Register Reference: SD22A/0428

Development: Permission for a development previously granted (and now lapsed) under Reg. SD07A/0367 & SD16A/0338; Warehousing Block B4 (11.55m high) divided into 8 units totalling 3, 484sq.m including 720sq.m ancillary offices / staff facilities on two floors and 2, 764sq.m warehousing area; Completion of ancillary carparking adjacent to the subject block and throughout the overall site, services, utilities, landscaping (including new flood mitigation berm to the northeast & southeast of the subject block), drainage works including additional surface water attenuation system plus all site development works.

Location: Block B4, Site B, Aerodrome Business Park, Collegeland, Rathcoole, Co. Dublin

Roads Department – Planning Report

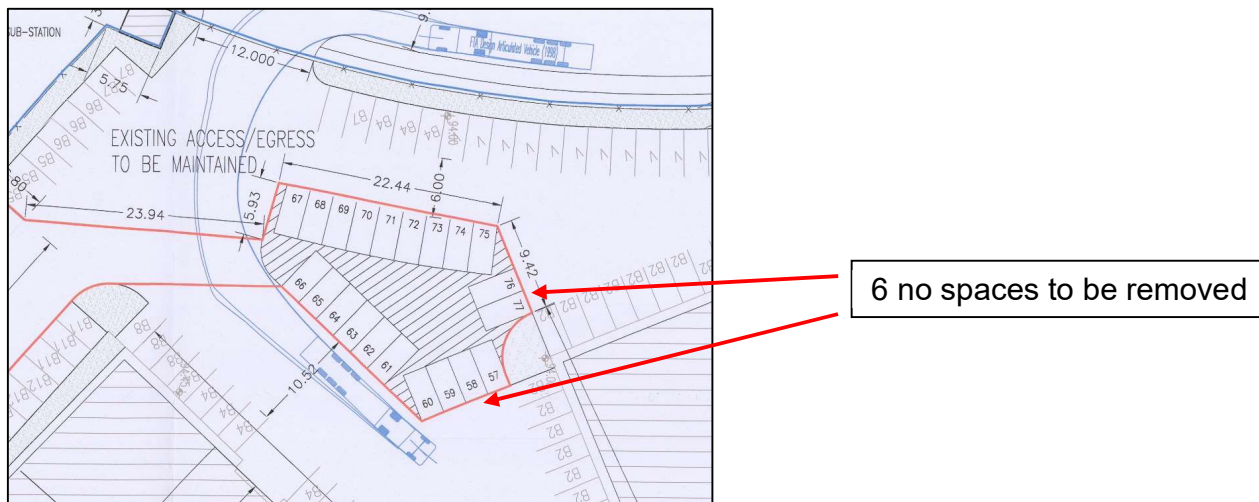
The applicant should show clearly demarcated 2-metre-wide pedestrian walkways between parking spaces and the main entrance.

The proposed car parking spaces have been calculated in line with Table 12.25 (Maximum Parking Rates) of the SDCC Development Plan 2022-2028. These however are **maximum** rates and should not be exceeded. Therefore, the applicant should submit a revised parking layout with a maximum of 40 no. car parking spaces.

In their revised parking layout, the applicant should remove parking spaces numbered 57-60 and 76-77, as car entering/exiting these spaces could cause a traffic hazard to cars in the existing Block B2 parking spaces.

1. The applicant shall submit a revised layout showing clearly demarcated 2-metre-wide pedestrian walkways between parking spaces and the main entrance.
2. The applicant shall submit a revised parking layout with a maximum of 40 no. car parking spaces provided. The revised layout should not include the parking spaces numbered 57, 58, 59, 60, 76 and 77, as shown on the previously submitted layout drawing, as they constitute a traffic hazard.
